**Plans and Minutes of Town Planning Board
Meeting held on 8.5.2020**

**加路連山道用地的概念方案
CONCEPTUAL SCHEME FOR CAROLINE HILL ROAD SITE**

就黃泥涌分區計劃大綱草圖編號S/H7/20
提出的申述個案編號R1-R634及相關意見編號C1-C105作出考慮
CONSIDERATION OF REPRESENTATIONS No. R1-R634 AND
RELATED COMMENTS No. C1-C105 TO THE DRAFT
WONG NAI CHUNG OUTLINE ZONING PLAN No. S/H7/20

圖 PLAN
H - 7a

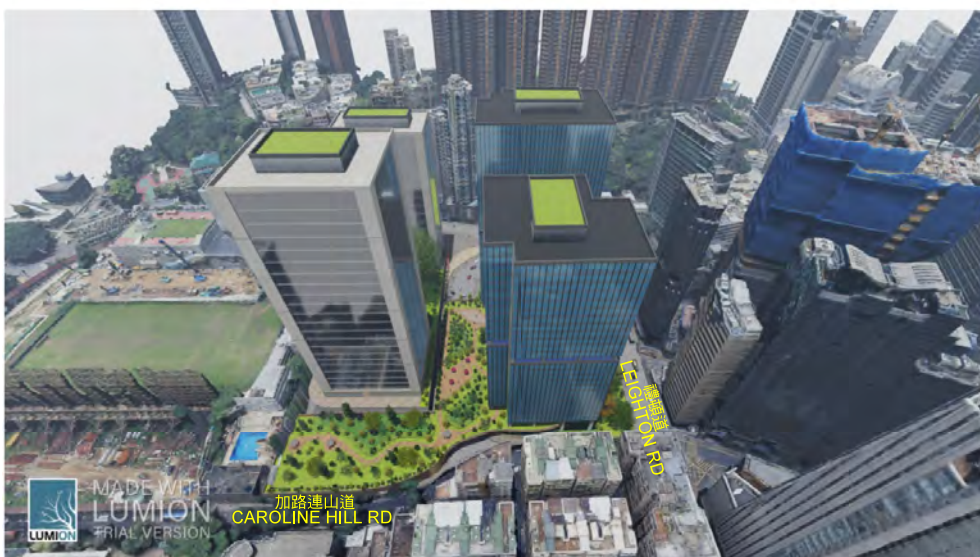
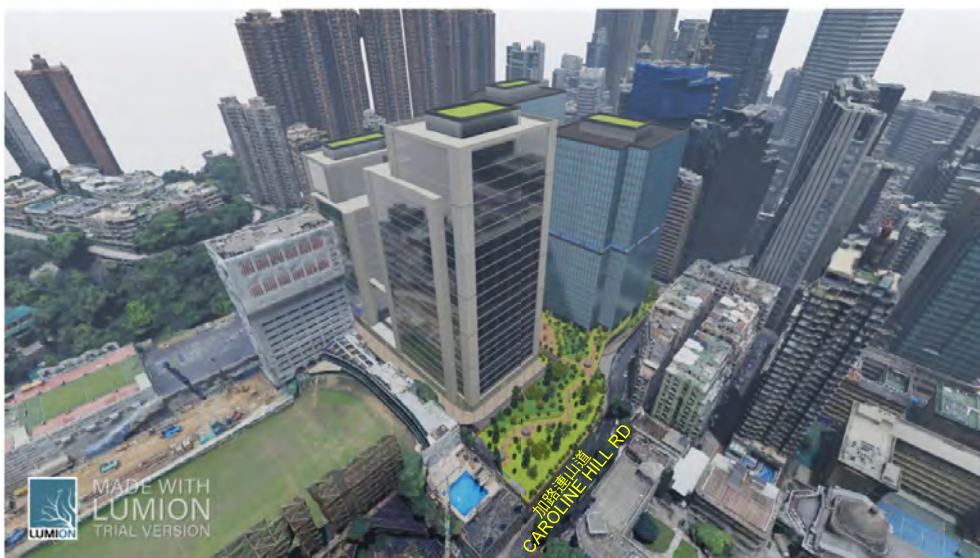
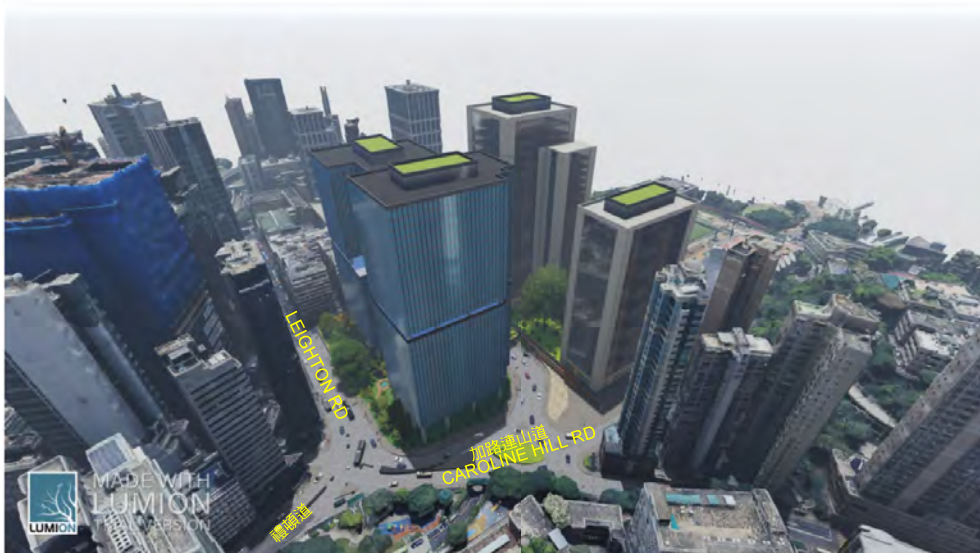
- (i) referring to the government scheme that a 25m-wide building gap had been provided within the site between the two commercial towers, whether the building gap of 20m between the district court buildings near CHR(West) and the residential development opposite them were sufficient, and whether the building gap could be widened;

- (k) besides DHC and CCC, whether additional GIC facilities could be provided at the site;
- (l) in response to the concerns of Members, a revised conceptual layout with disposition of the district court buildings set back further from CHR(West) had been provided by PlanD during the further consideration of proposed amendments to the approved Wong Nai Chung OZP (as detailed in Plan FC-3 of MPC Paper No. 5/19). Noting R26's request for a NBA of 40m, what the distance was between the south-western edge of the district court building and the residential buildings at CRH(West) in the revised conceptual layout; and

- (m) whether there was scope to swap the location of the open space at the north-eastern corner of the site and the district court buildings.

- (a) the access road shown in the government scheme was indicative in nature. The future developer could consider different arrangements for the access road, including decking over it;
